## **SAFETY ALERT / SAFETY DIRECTIVE**

Upgrading the bellcrank control system of the STOL CH 750.

Factory built AMD SLSA CH 750 STOL, all serial numbers.

Updating the bellcrank control tube with an AN4 bolt through the existing tube.

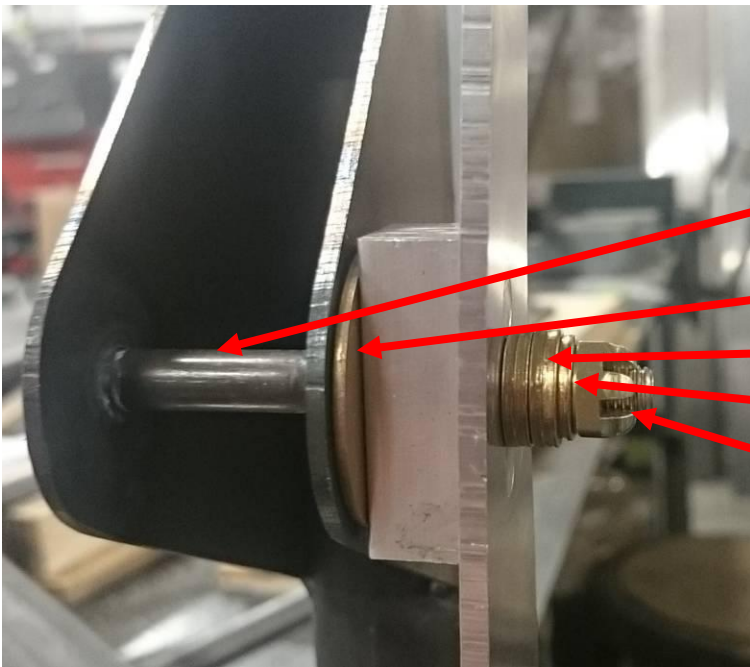
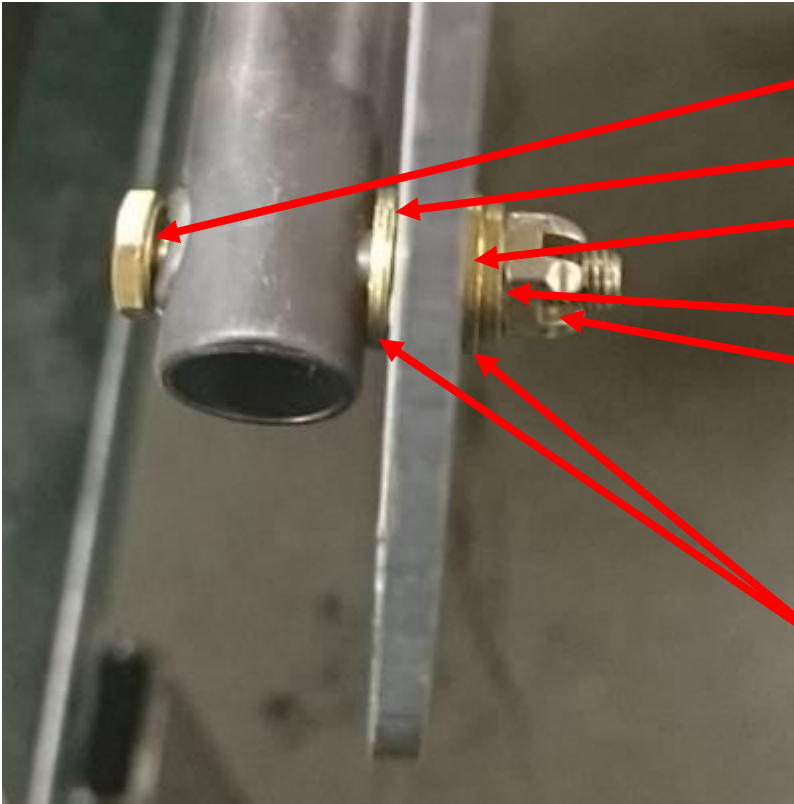
**Existing bellcrank connection**

Remove cotter pin etc.

Drill inside the 5/16" welded tube for an AN4-26 bolt.

**New bellcrank connection**

AN4-26 bolt through the existing welded tube.

1 penny washer 5/16"

4 washers 5/16" or as required

1 washer 1/4"

1 Castle nut with cotter pin

Completed assembly needs to be snug and free of sloppiness but easy to rotate.

- 1) Torque Tube 75C2-5. Drill through the welded 5/16" tube with a 1/4" drill bit and install an AN4 bolt through the tube. This can be drilled without removing the torque tube from the aircraft. Add washers to hold the elevator bellcrank close to the tube and secure with a castle nut and cotter pin. Do not add more than one washer between the bellcrank and the tube. If the tube is deformed, contact Zenair Ltd and do not fly the aircraft.
